MARK	DATE	DESCRIPTIONS	BY	CH'D	CCO#
2	06/22/07	WELDED PADEYES	NV	TH	41
1	04/20/07	WEST ANCHORAGE ACCESS DETAILS	GB	TH	28

SAN FRANCISCO OAKLAND BAY BRIDGE
EAST SPAN SEISMIC SAFETY PROJECT
SELF-ANCHORED SUSPENSION BRIDGE
(SUPERSTRUCTURE & TOWER)

WEST ANCHORAGE ACCESS DETAILS NO. 3

REQUESTS FOR INFORMATION NOT ADDRESSED IN THIS CCO REMAIN IN FORCE					
2	02/12/08	PADEYE MODIFICATIONS	NV	MN	41
1	06/22/07	WELDED PADEYES	NV	MN	41
MARK	DATE	DESCRIPTIONS	BY	CH'D	CCO#
REVISIONS

TYPICAL GIRDER ACCESS LAYOUT

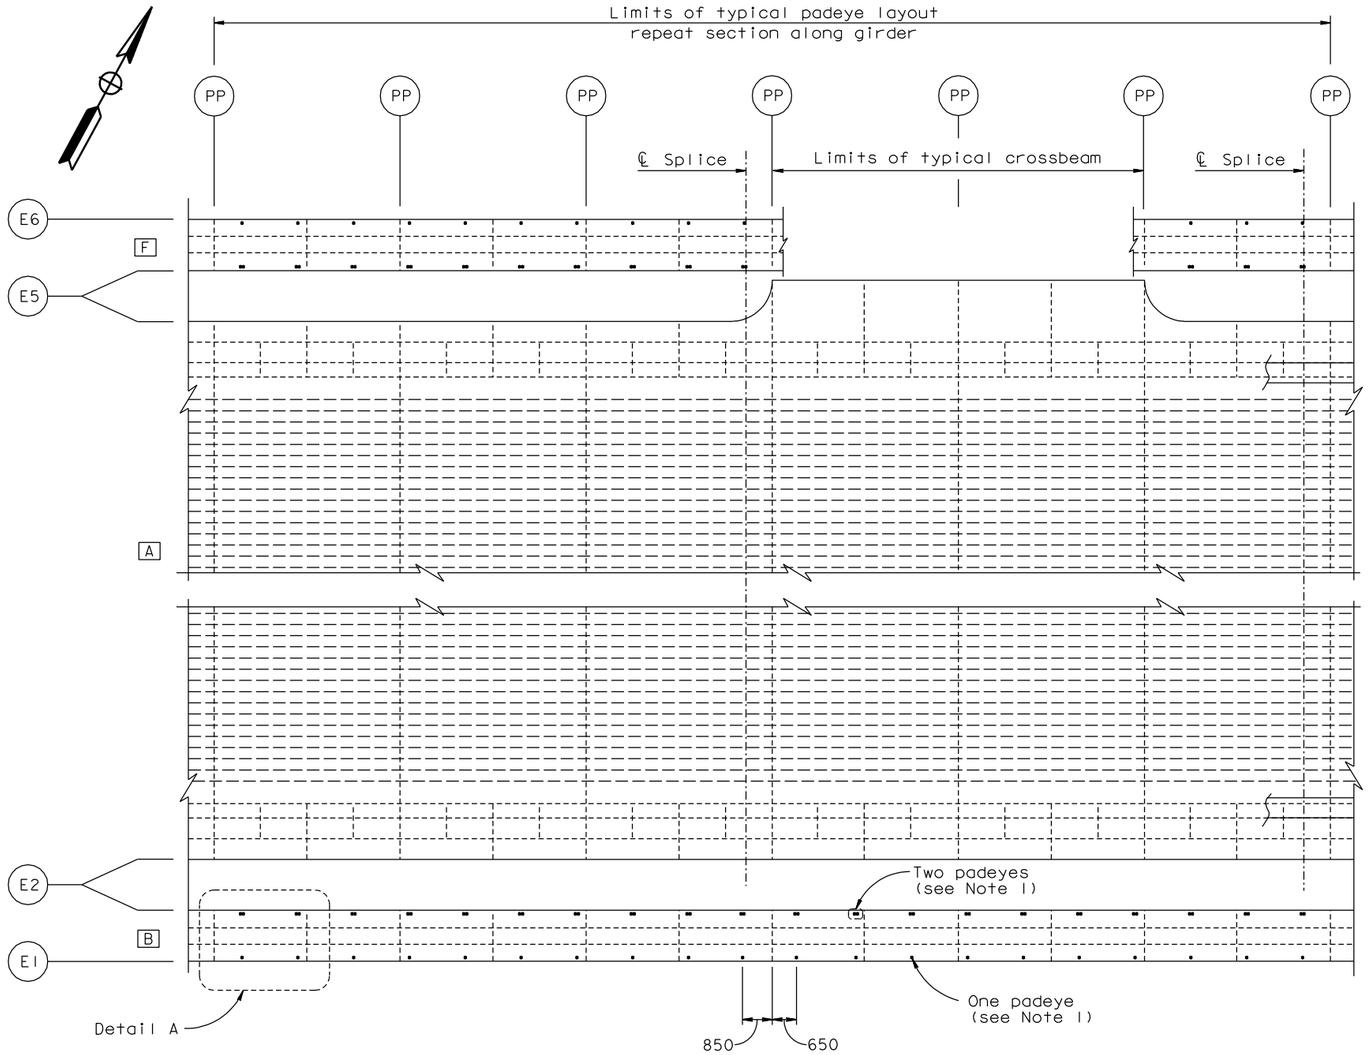
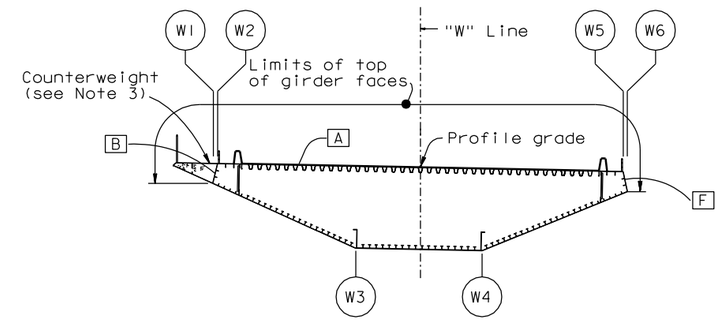
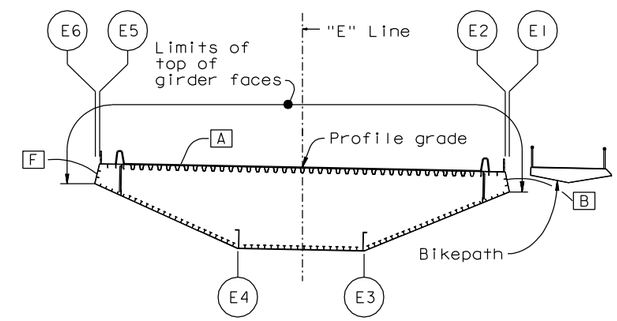
MARK	DATE	DESCRIPTIONS	BY	CH'D	CCO#
1	05/01/09	PADEYE MODIFICATIONS	GB	MN	41

1. For Detail A and padeye details, see "Girder Access Details No.10" sheet.
2. For girder framing and layout, see "Girder Framing Details No.1" sheet.
3. For padeye locations on counterweight, see "Girder Access Details No.9" sheet.
4. Eliminate the detailed padeyes on the box girder, including the bikepath and the counterweights, unless directed otherwise by the Engineer. (1)

GIRDER ACCESS LAYOUT AT EAST TRANSITION ("E" Line shown, "W" Line similar)

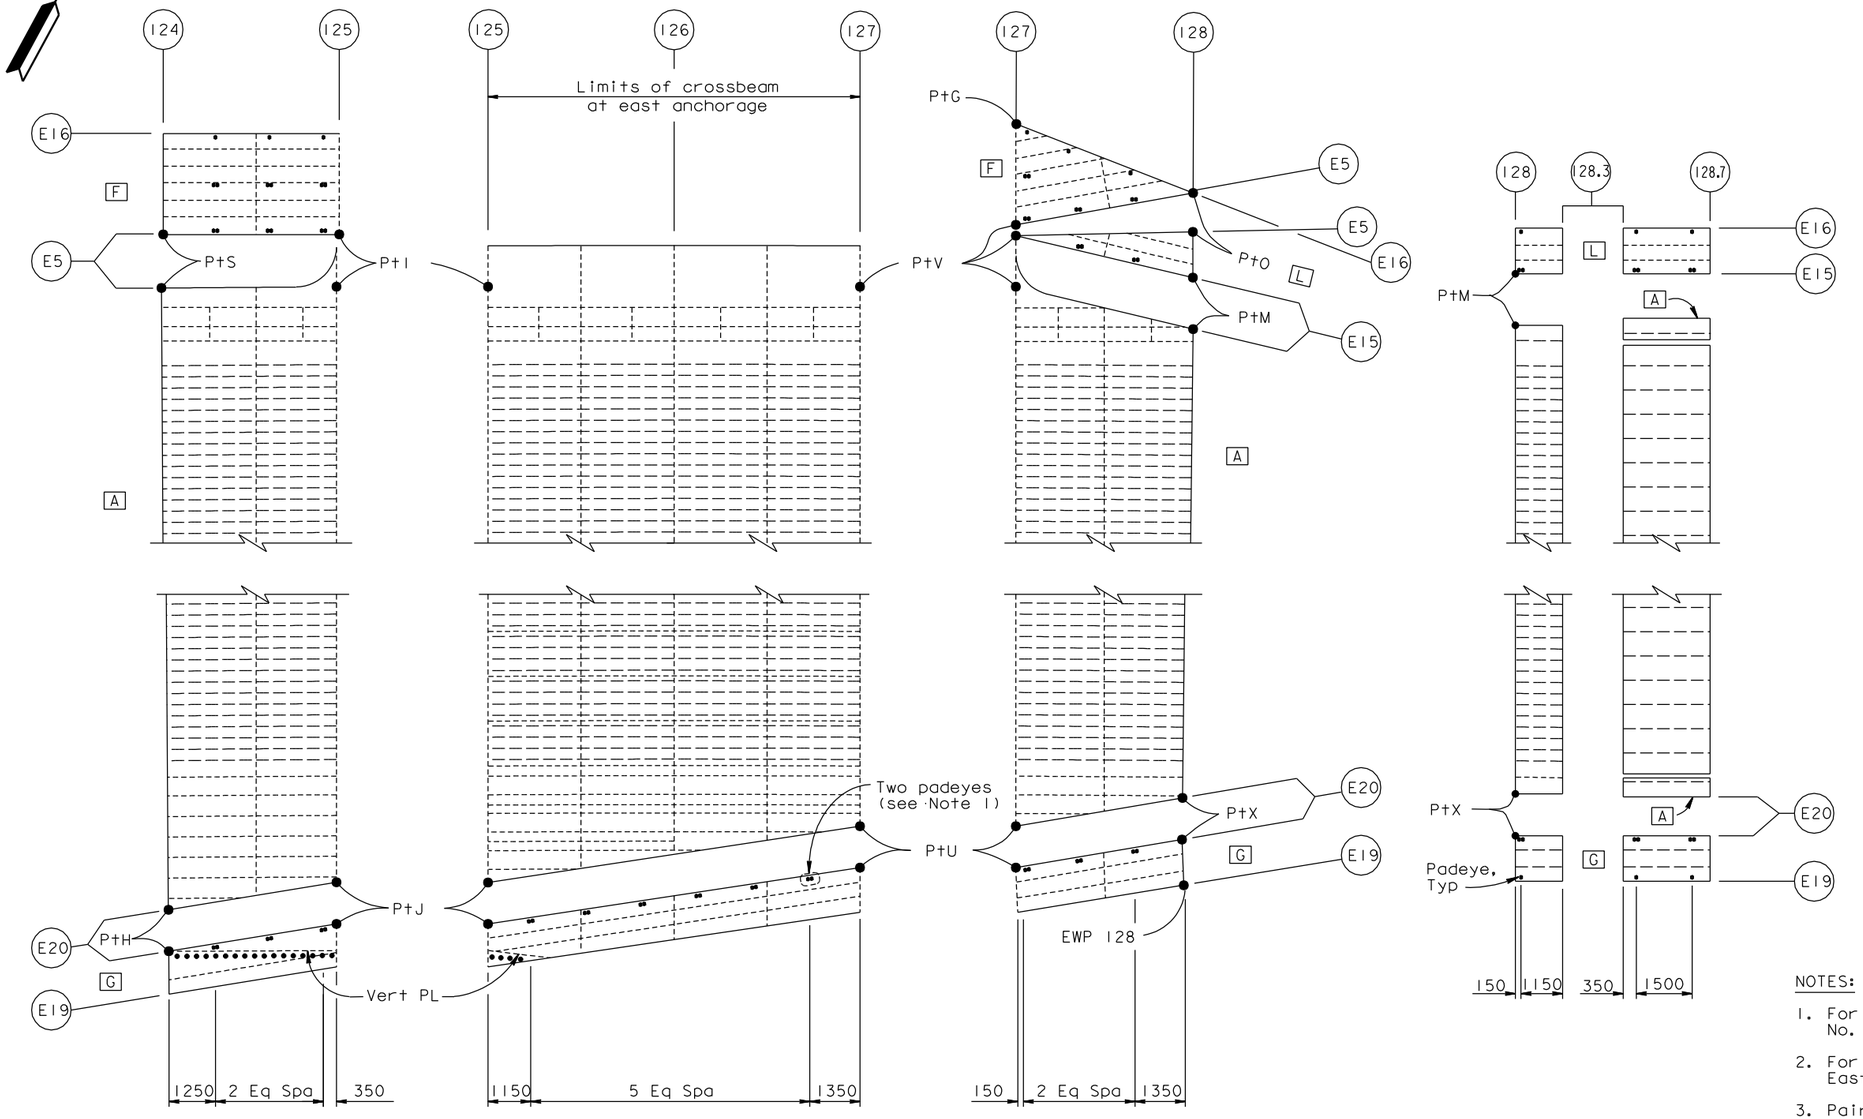
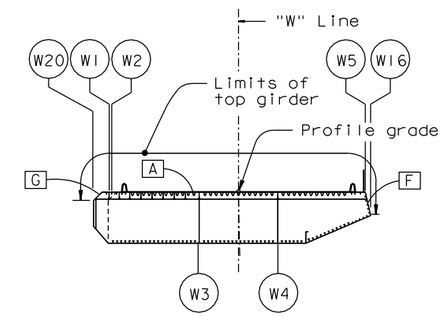
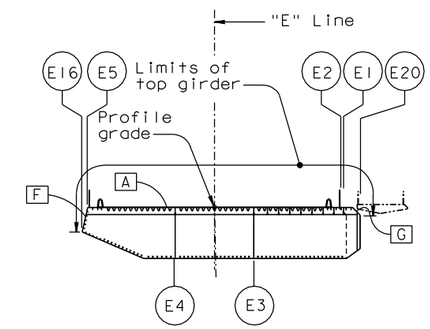
MARK	DATE	DESCRIPTIONS	BY	CH'D	CCO#
1	05/01/09	PADEYE MODIFICATIONS	GB	MN	41

1. For padeye details, see "Girder Access Details No.10" sheet.
2. For girder framing and layout, see "Girder At East Transition No.12" sheet.
3. Pairs of pad eyes shall be aligned to be level.
4. For padeyes at architectural splice, see "Girder Access Details No.10" sheet.
5. Eliminate the detailed padeyes on the box girder, including the bikepath and the counterweights, unless directed otherwise by the Engineer.

TYPICAL BIKEPATH ACCESS LAYOUT

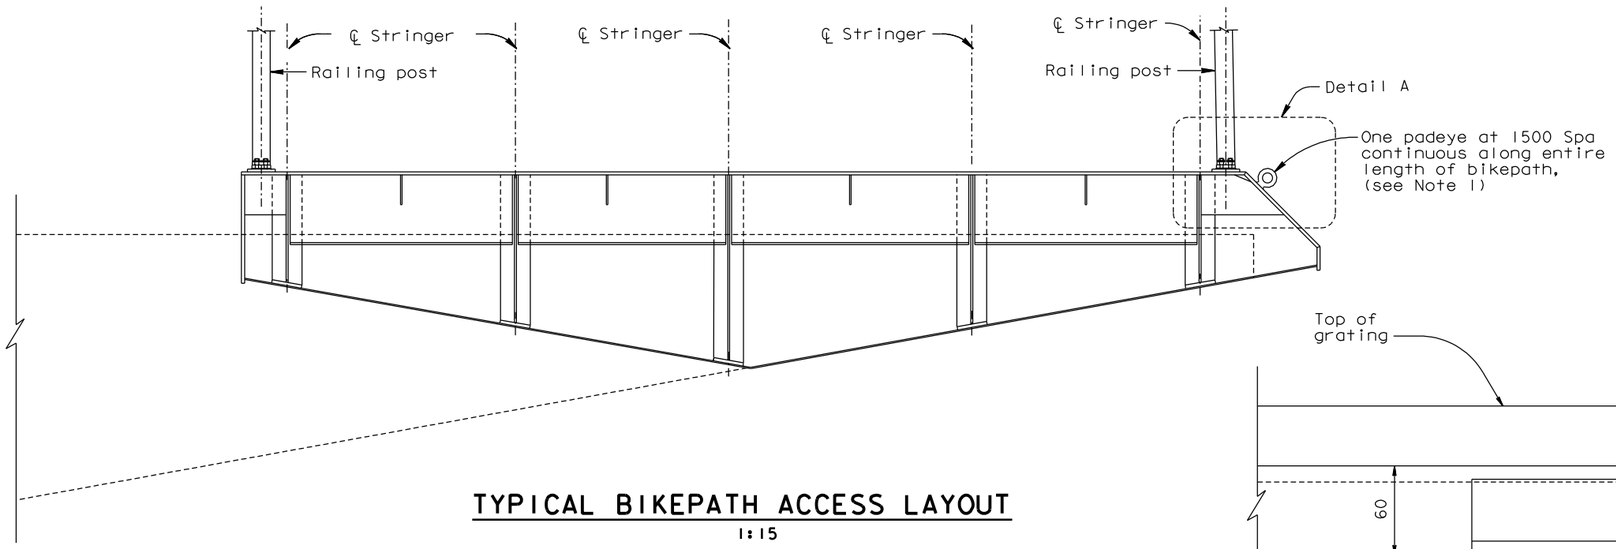
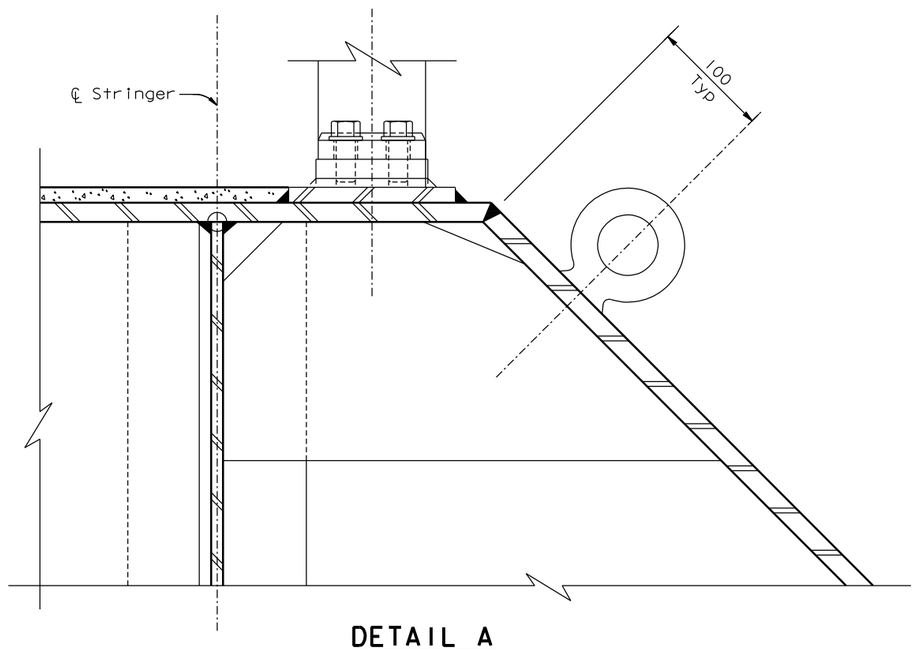
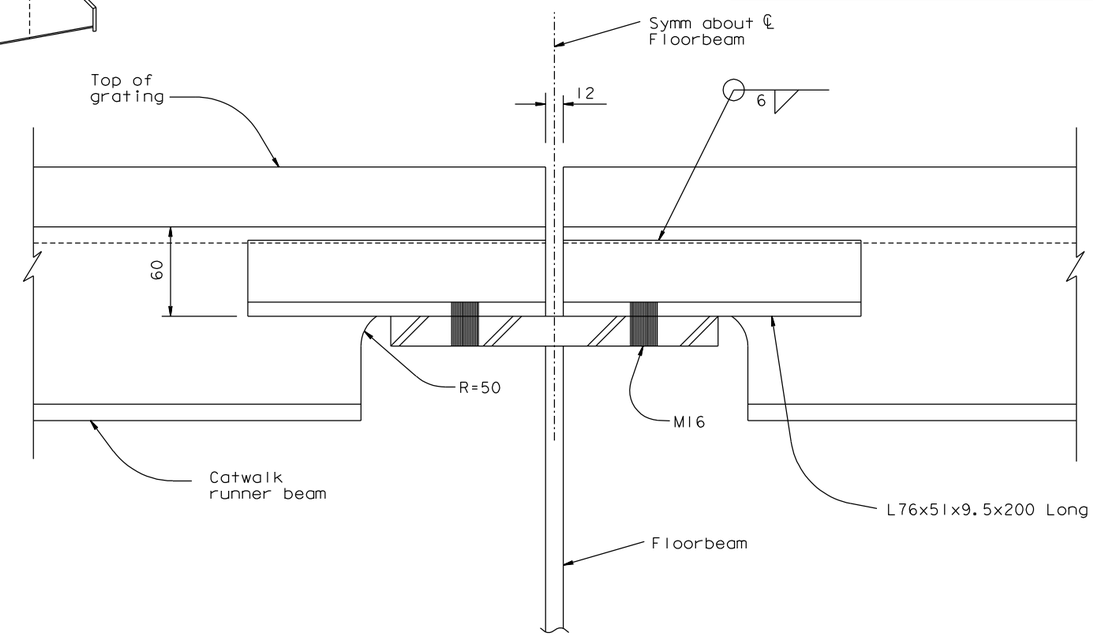
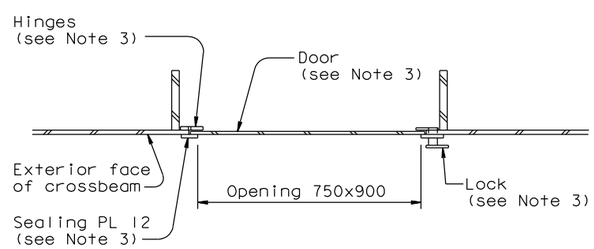
MARK	DATE	DESCRIPTIONS	BY	CH'D	CCO#
2	05/01/09	PADEYE MODIFICATIONS	GB	MN	41
1	06/22/07	WELDED PADEYES	NV	MN	41

1. For bikepath padeye detail, see "Girder Access Details No.10 sheet.
2. For bikepath details, see "Bikepath Details" sheets.
3. For details not shown, see "Access Opening With Door At Vertical Face Of Tower Strut Facade" and "Access Opening Door Detail" on "Tower Access Details No.4" sheet.
4. Eliminate the detailed padeyes on the box girder, including the bikepath and the counterweights, unless directed otherwise by the Engineer. (2)

COUNTERWEIGHT ACCESS LAYOUT

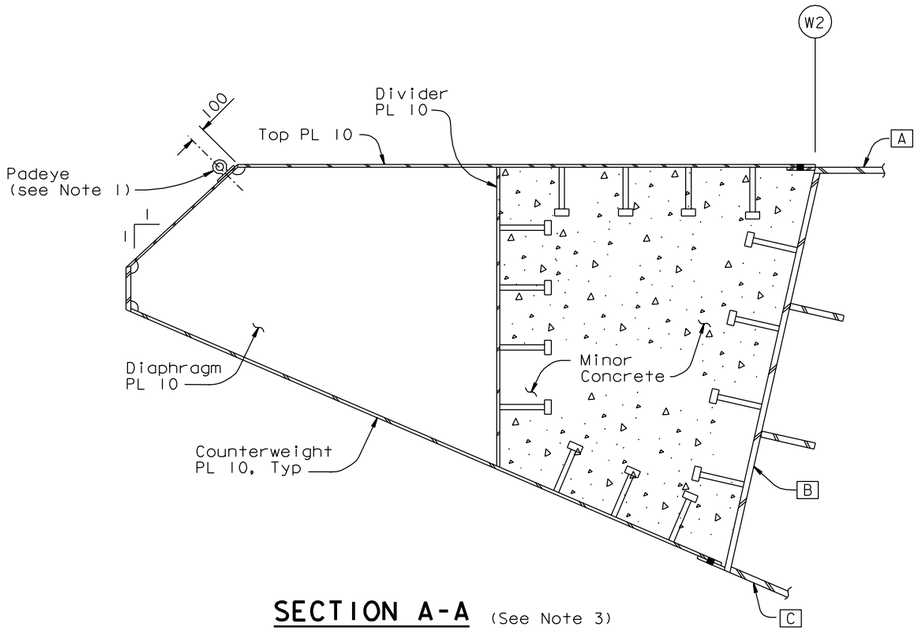
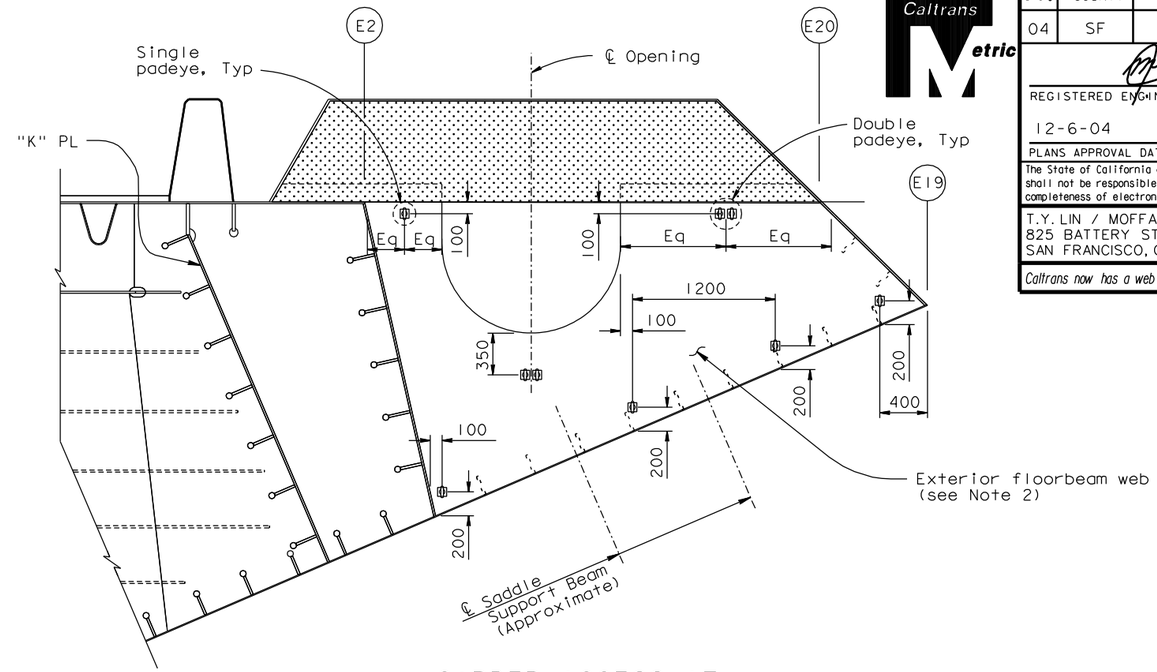
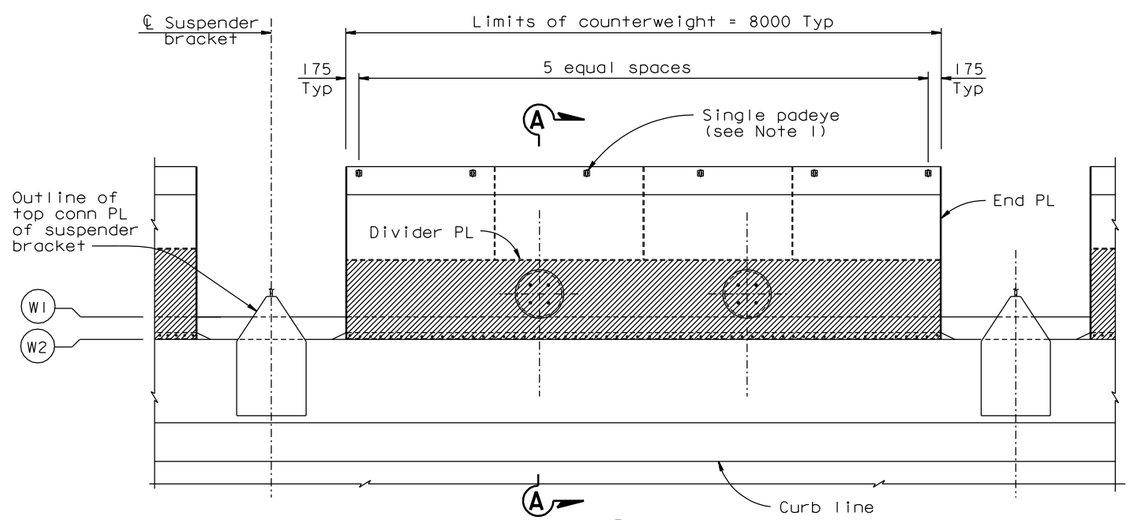
MARK	DATE	DESCRIPTIONS	BY	CH'D	CCO#
1	05/01/09	PADEYE MODIFICATIONS	GB	MN	41

1. For counterweight padeye use "Padeye At Bikepath Detail", see "Girder Access Details No. 10" sheet.
2. For saddle housing details, see "East Saddle Housing Details" sheets.
3. For counterweight details, see "Typical Girder Details No. 17" sheet.
4. Eliminate the detailed padeyes on the box girder, including the bikepath and the counterweights, unless directed otherwise by the Engineer.

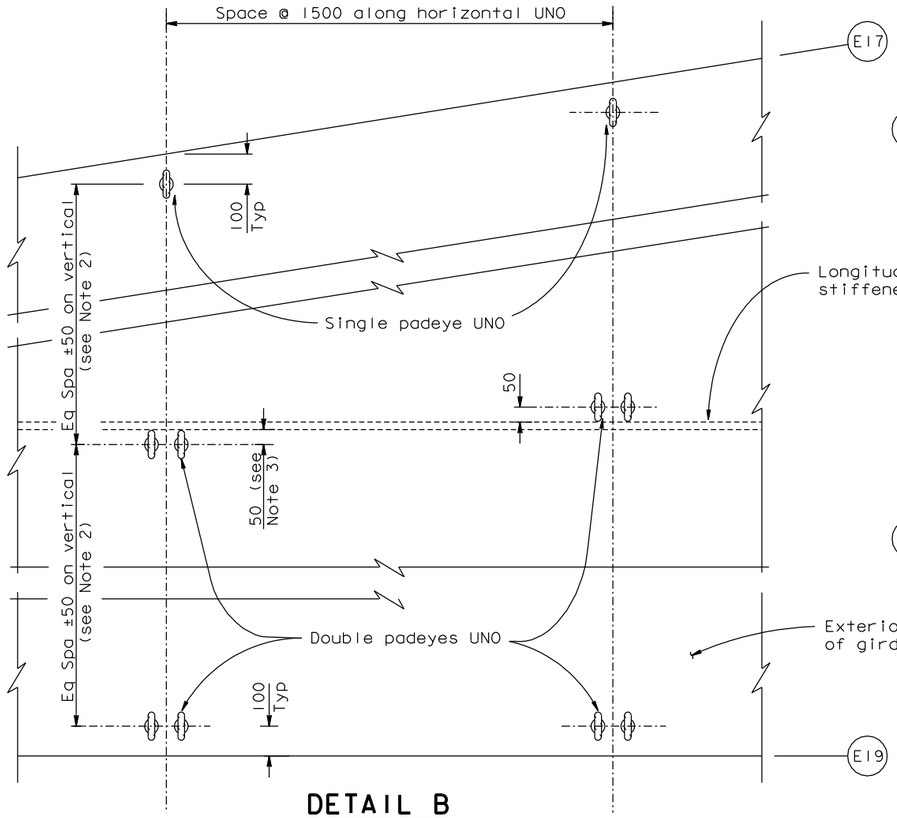
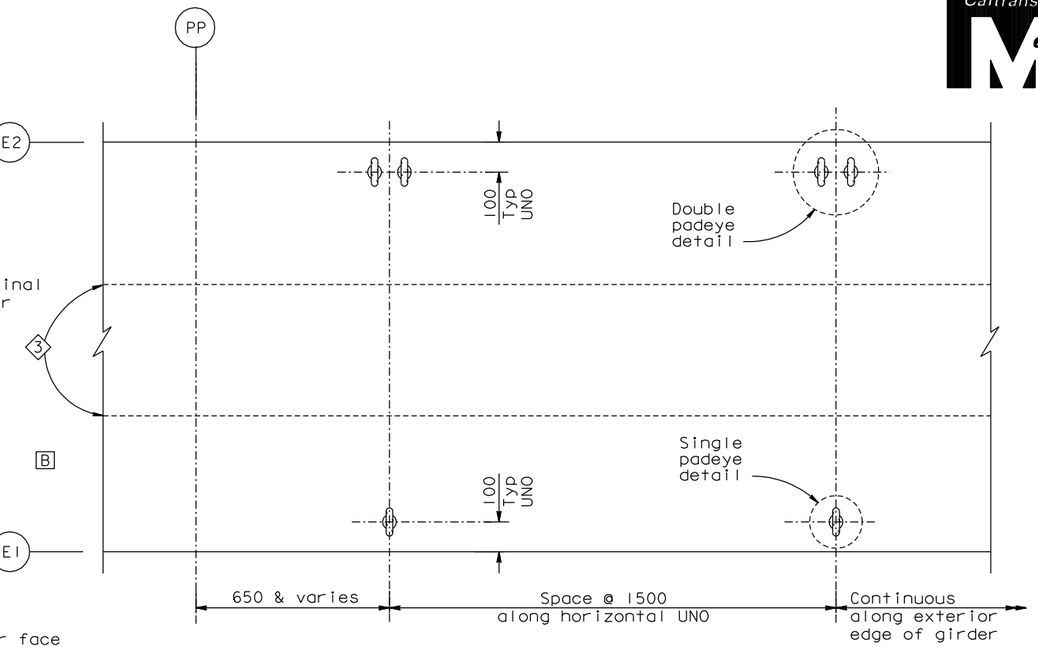
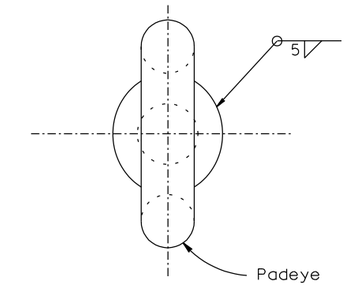
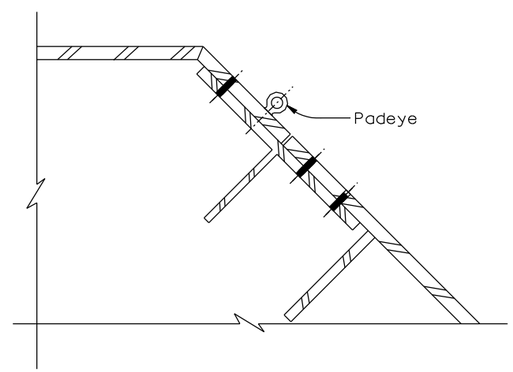
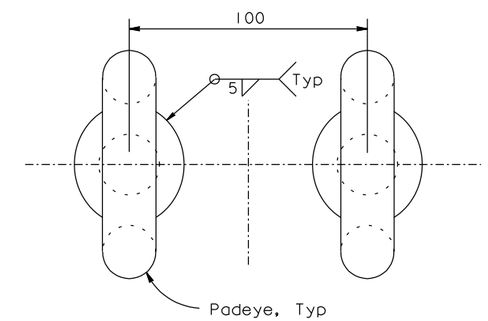
MARK	DATE	DESCRIPTIONS	BY	CH'D	CCO#
3	05/01/09	PADEYE MODIFICATIONS	NV	MN	41
2	04/30/08	WELDED PADEYES	NV	MN	41
1	06/22/07	WELDED PADEYES	NV	MN	41
